Subject: Front Steering Hoses Recall

Bulletin Type: Service Campaign Recall

Bulletin No: TS45-SR-1901

Vehicle Model: TS45

Figure-3

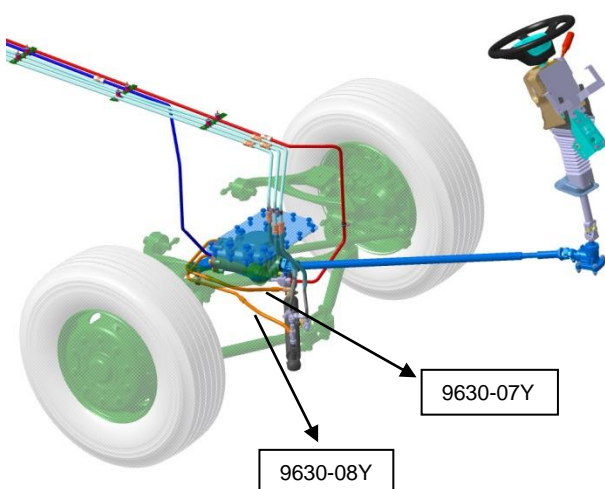
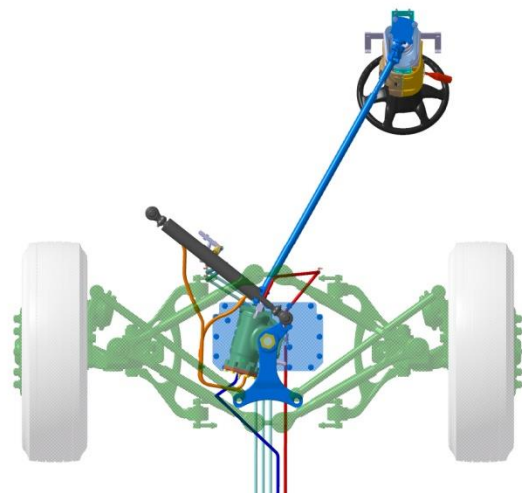
4. The 9630-07Y and 9630-08Y numbered steering hoses (shown with orange color) will be replaced (See Figure-3 and 4)

Figure-5

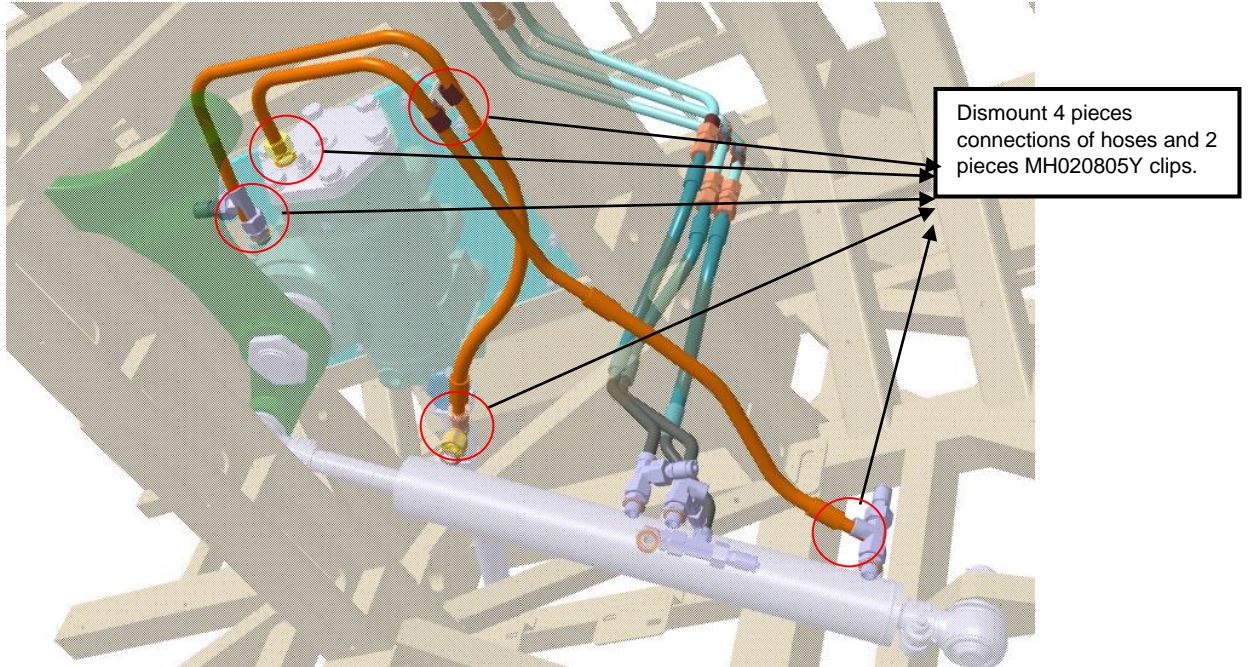
- To dismount the steering hoses, remove the connectors and clips which is shown in picture below (**See Figure-5**)

Figure-6

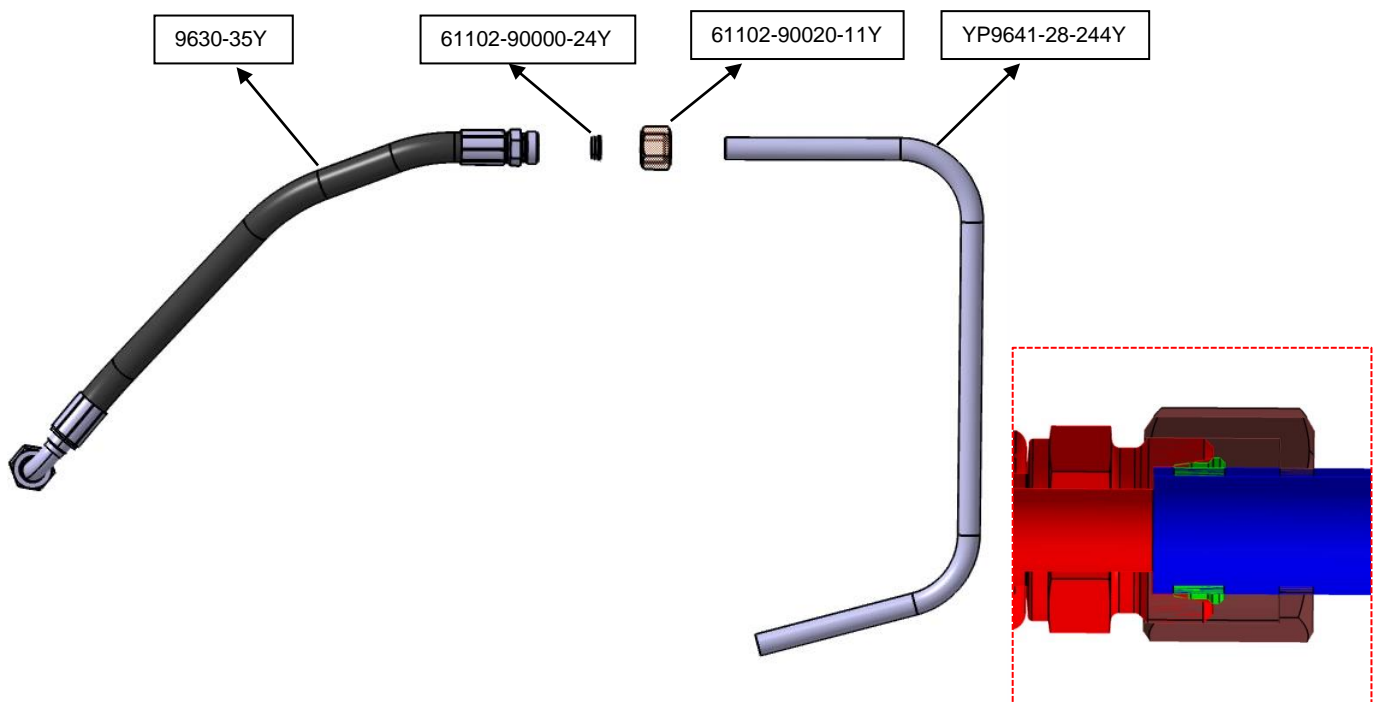
- Mount the 9630-35Y numbered hose and YP9641-28-244Y numbered pipe with using 61102-90000-24Y and 61102-90020-11Y as showed in the **Figure-6**. (Look at the Note-1 in page 11 for the tightening procedure.)

Figure-7

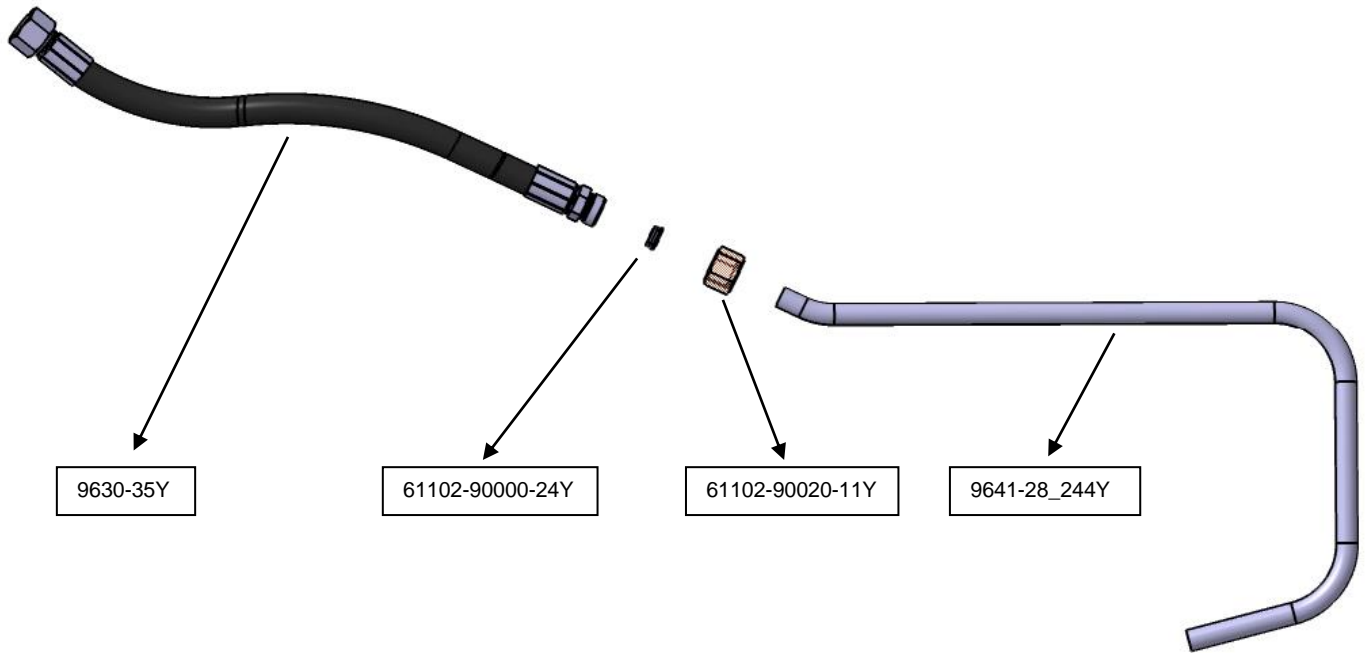
7. Mount the 9630-36Y numbered hose and 9641-28\_247Y numbered pipe with using 61102-90000-24Y and 61102-90020-11Y as showed in **Figure-7**. (Look at the Note-1 in page 11 for the tightening procedure.)

Figure-8

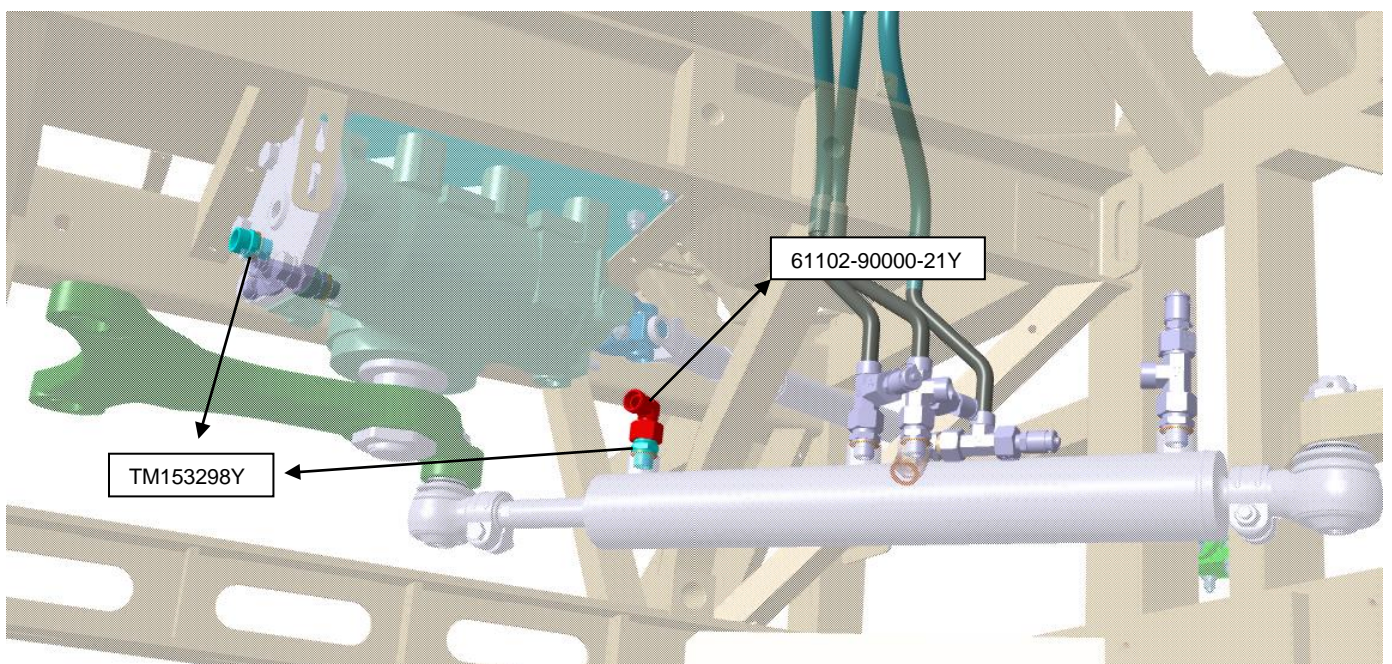
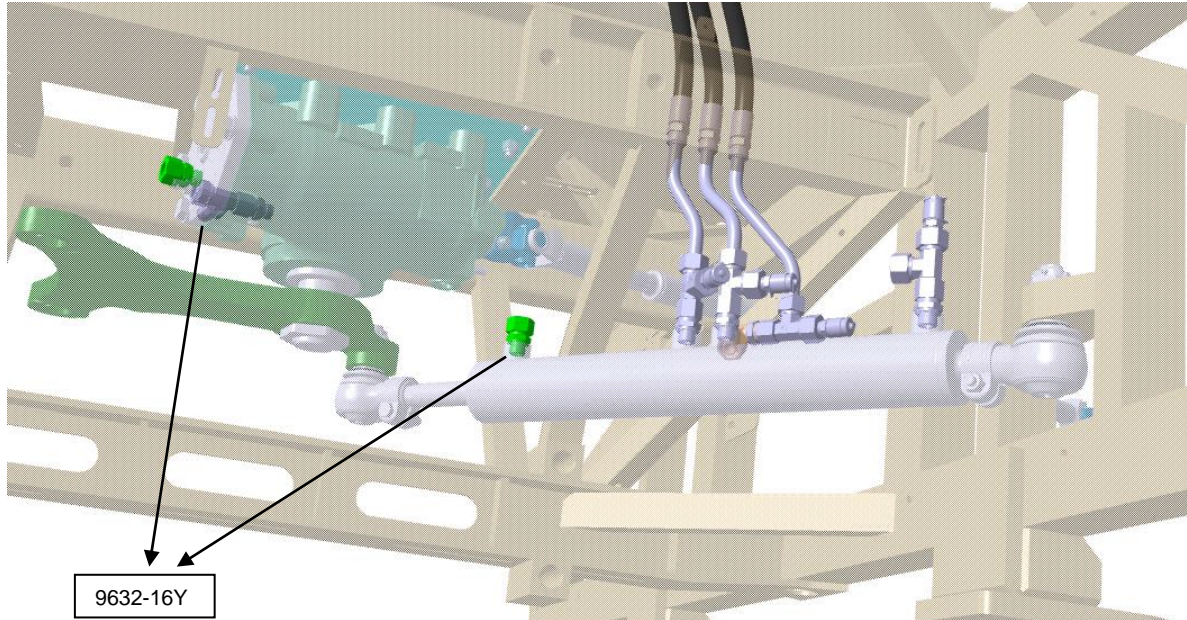
8. Dismount two pieces TM153298Y numbered connector (shown with blue color) and one piece 61102-90000-21Y (shown with red color) connector which is showed in **Figure-8**.

**Figure-9**

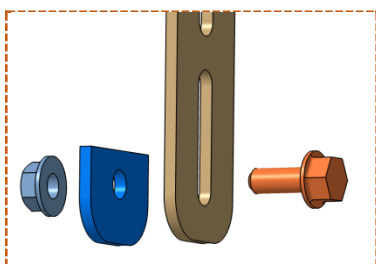
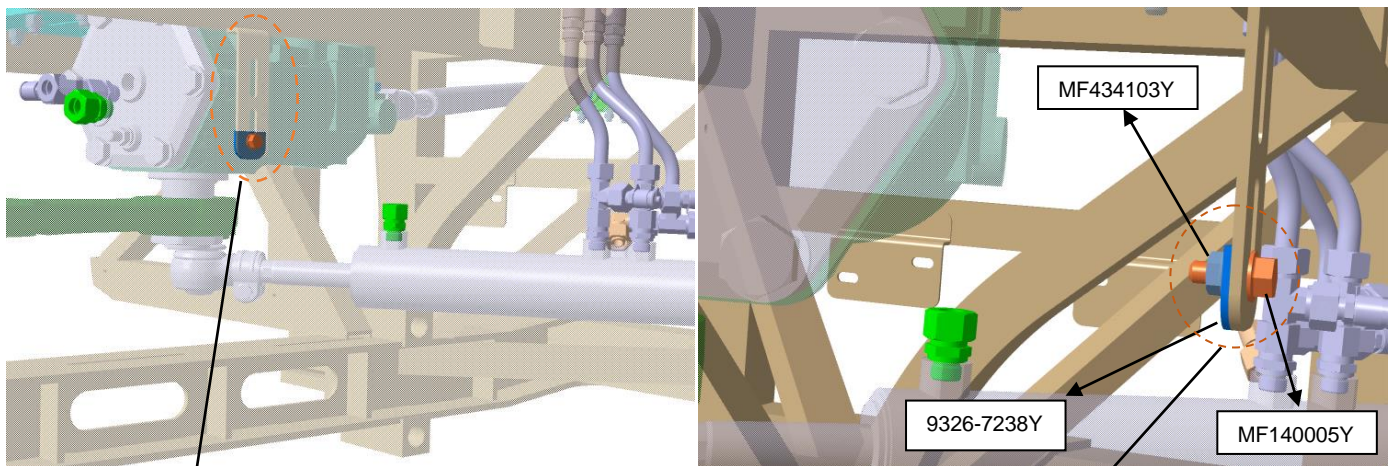
9. Mount two 9632-16Y (shown with green color) connector which is shown in **Figure-9** (Look at the Note: 1 in page 11 for the tightening procedure.)

Figure-12

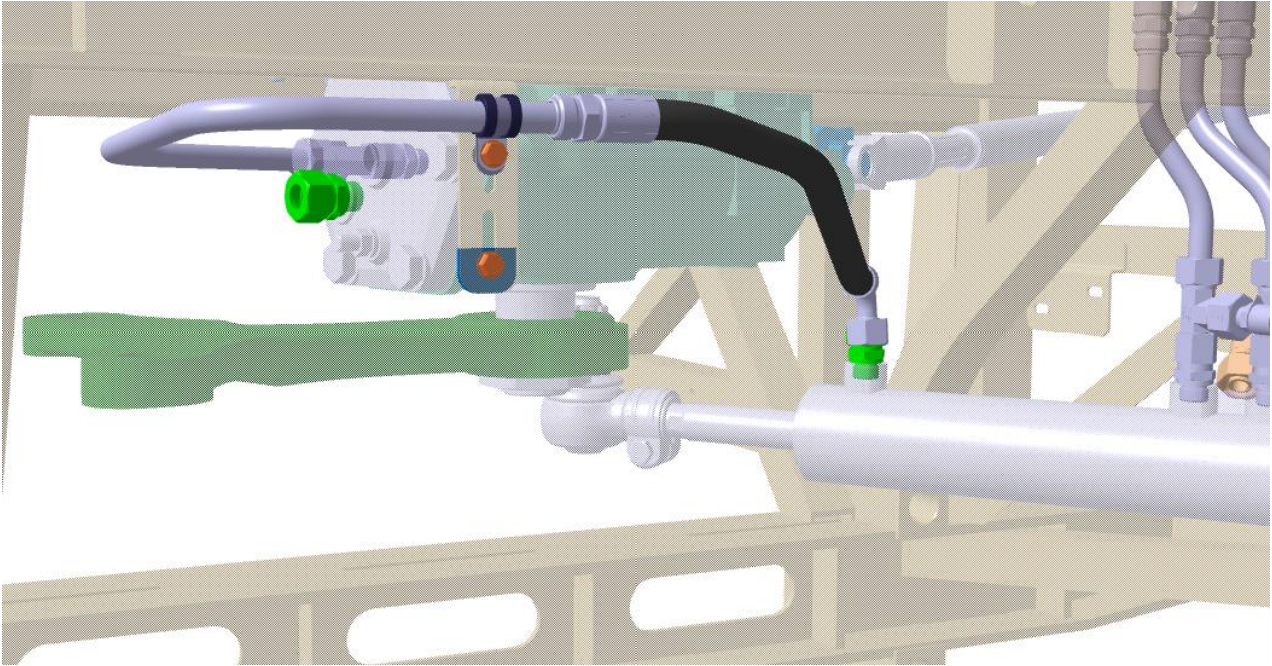
11. Mount hose (9630-35Y and 9641-28\_244Y) as shown in **Figure-12**. Use new 61102-90000-24Y and 61102-90020-11Y on the steering box side. (Look at the Note-1 in Page 11 for the tightening procedure.) Fix the hose and pipe on the chassis with MH020805Y numbered clip (Tightening torque value is **3.69 ft-lb / 5Nm**).

Figure-13

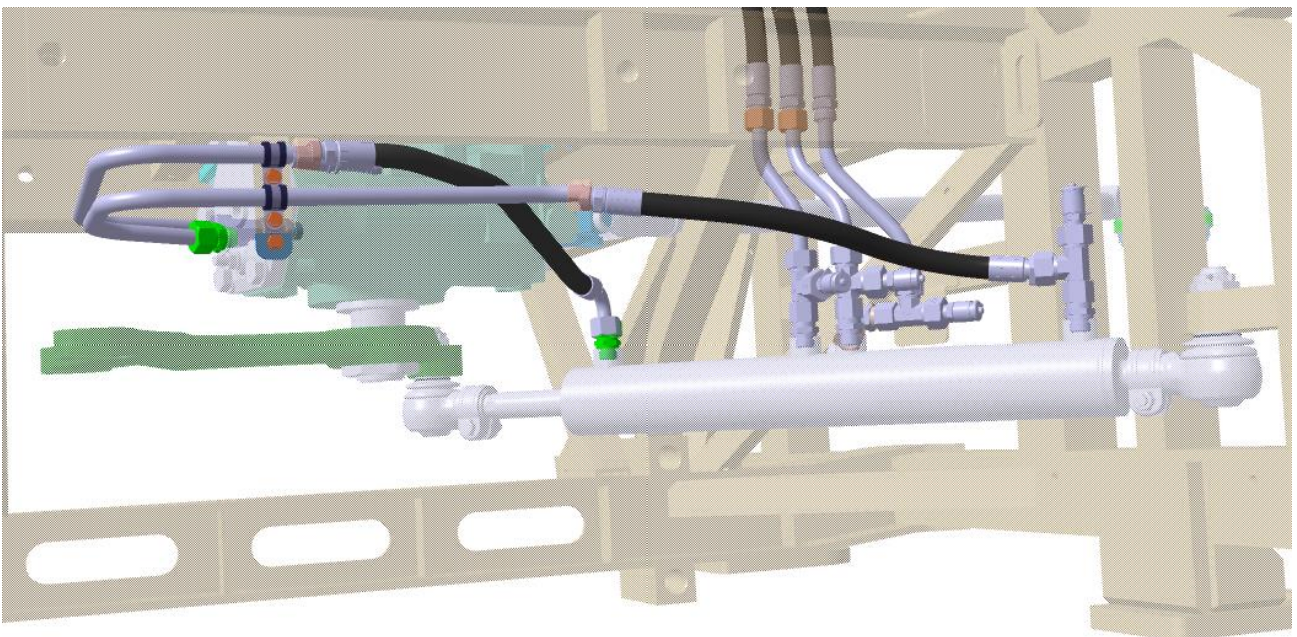
12. Mount 9630-36Y and 9641-28\_247Y as shown in **Figure-13**. (Look at the Note-1 in page 11 for the tightening procedure.) Use new 61102-90000-24Y and 61102-90020-11Y on the RAS cylinder connections. Fix the hose and pipe on the chassis with MH020805Y numbered clip
